FEMA PAL Response Report

SANTA CLARA RIVER LEVEE (SCR-1)

HIGHWAY 101 TO SATICOY

FEMA ID No. 18

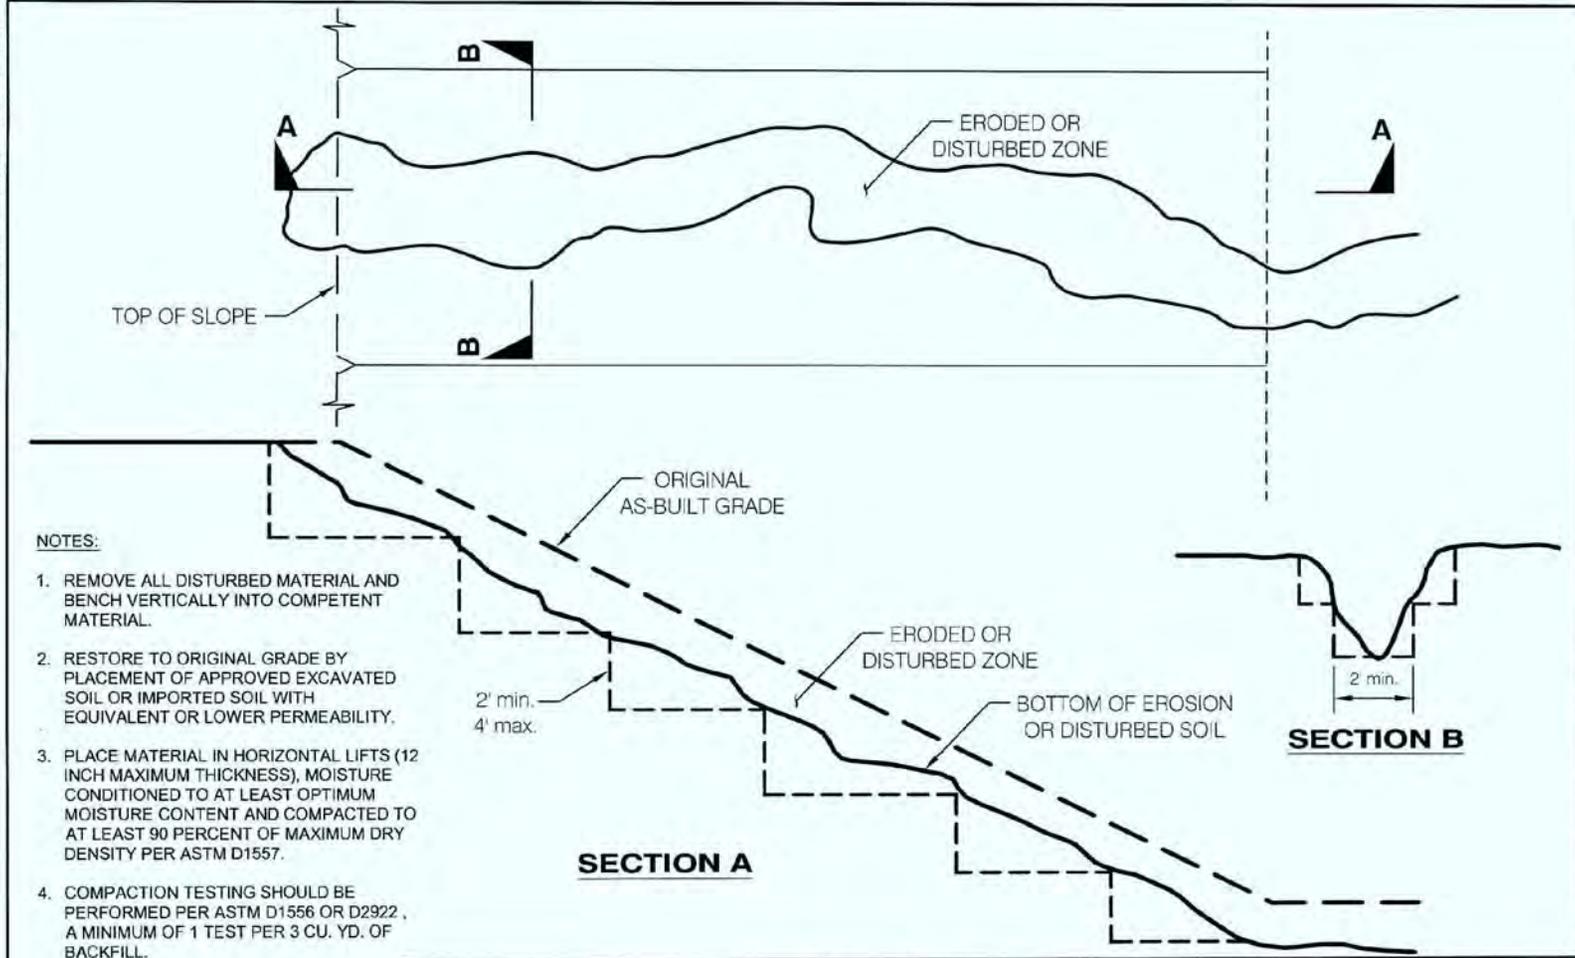
<p>4. Can Tetra Tech provide specs for compaction and grading requirements? Discuss major and minor repair examples.</p>	<p>Compaction requirements are detailed on the attached Figures 1 and 2. Major repair examples include any erosion feature that is deeper than 1 foot or that is greater than 2 feet wide. Major and minor animal burrows are discussed in item 1.</p>
<p>5. Can in-kind materials be used for backfill?</p>	<p>In-kind backfill would be materials free of organic or deleterious debris that has similar or lower permeability than the levee material. These materials could consist of excavated soil, imported soil, concrete, or slurry, and shall be evaluated by the testing and materials lab.</p>
<p>6. Discuss documentation/inspection requirements for verification of grading.</p>	<p>The requirements for verification of grading are discussed above.</p>
